## CLAUSE 52.20 COUNCIL CONSULTATION ADVICE

| <b>Property Address:</b>     | 61 Johnson Street RESERVOIR VIC 3073                                                         |
| <b>Pre-App Number:</b>       | PRA/69/2026                                                                                  |
| <b>Proposal Description:</b> | Homes Victoria is preparing to develop the site with around 80 social housing dwellings      |

### 3. Slab Building

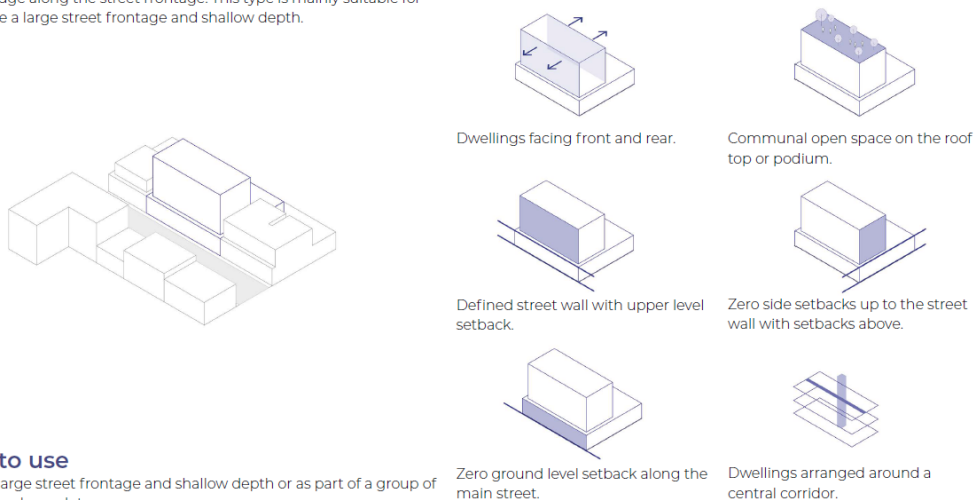
- Proposed twin tower arrangement results in an inefficient building layout, including an inactive western interface to rail corridor, complex internal layouts and a reliance on narrow light courts. Given the site's generous street frontage and relatively shallow depth, a slab building typology is considered a more appropriate built form outcome in this context.

- Revise the upper-level layout to orientate apartments towards both primary street and railway corridor in accordance with slab typology. This will create a more active edge to the railway corridor improving passive surveillance / amenity to shared path and the building's overall interface with the public realm.

- Orientating apartments towards the railway corridor would also improve apartment amenity by allowing for better daylight access, privacy and outlook by reducing reliance on narrow, deep light courts. In current layout several bedrooms rely on these light courts for daylight, requiring opaque glazing and high sill windows to mitigate overlooking, resulting in poor outlook and reduced amenity.

- A slab typology would also enable a more efficient internal layout through a single centrally located double-loaded corridor, with opportunities for daylight and ventilation at each end. This would assist in improving the amenity and environment quality of internal circulation spaces.

##### *IEQ: Residential Daylight*

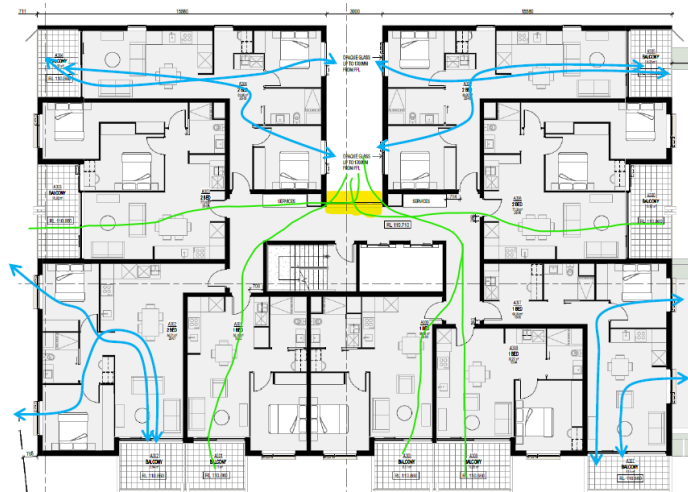
- The following floor plate designs are of concern due to the deep, narrow, single aspect living areas with a balcony overhang. While the development is meeting BESS compliance for daylight demonstrated by way of the BESS

built-in tool, these types of living spaces are difficult to account for daylight quality. It is recommended to reconsider the design to improve daylight outcomes.

Cross ventilation breeze paths at Level 3 (typical for Levels 2, 3, 4, and 5)

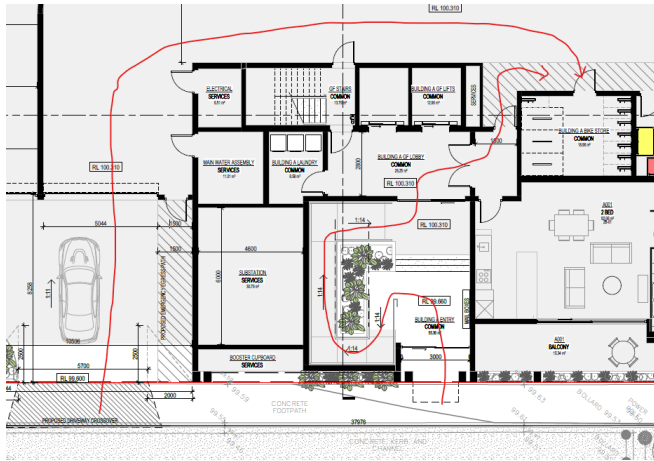
- The SMP shows and that only 34% of apartments are naturally ventilated. This is not supported. Design changes should be undertaken to improve natural ventilation throughout the building.
- A suggested approach to improving natural ventilation is to provide the corridor with an operable window and all apartments fitted with security doors so that residents can ventilate through their front door while maintaining security. See below a snip with yellow highlight where window operability could be located and green line markings of ventilation opportunities as a result of the change.
